# UNITED STATES PATENT AND TRADEMARK OFFICE

**Office Action Summary**

10/540,931

## DETAILED ACTION

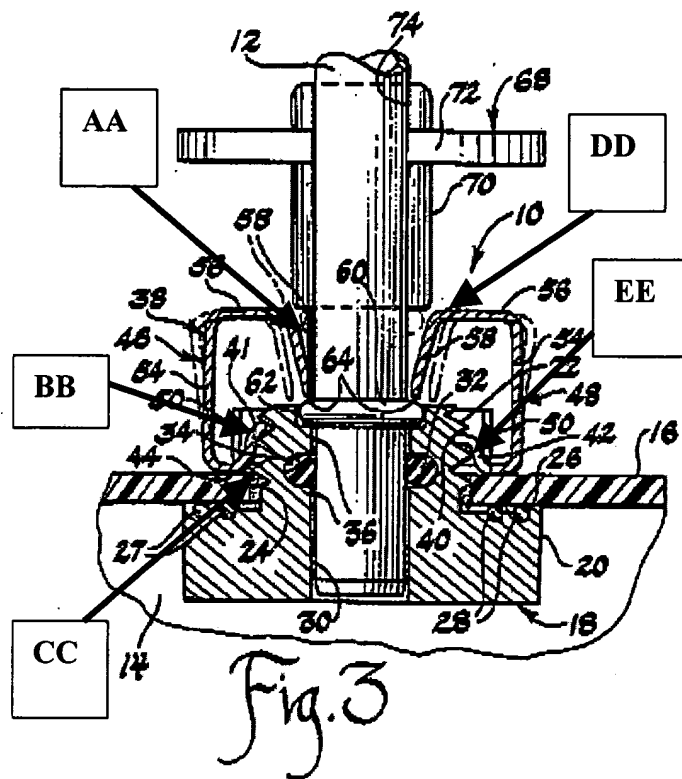
With regard to claim 1, and as shown in Figure 3 below, Beamer discloses a quick connecting device for ducts in motor vehicles intended for quick connecting the end of a first duct 18 to the end of a second duct 12, said one end of said first duct being adapted for snugly receiving a fastening clip 38 intended to hold axially in place the ends of both ducts, the outer surface of the end of said second duct being adapted for being housed inside the end of said first duct and said end having a circumferential groove AA in the outer surface thereof, characterized in that, when assembled, the end of the first duct is adapted to extend outward to said end of said second duct without covering said circumferential groove thereof, the surface of the end of said first duct having outer protrusions BB, CC defining respective inner recesses adapted for receiving sealing gaskets.

With regard to claim 2, Beamer discloses that the fastening clip is provided with two substantially U- shaped coupling members, one DD of which being fitted into said circumferential groove of the end of said second duct and the other one EE being fitted into the groove defined between said outer protrusions of the end of said first duct.
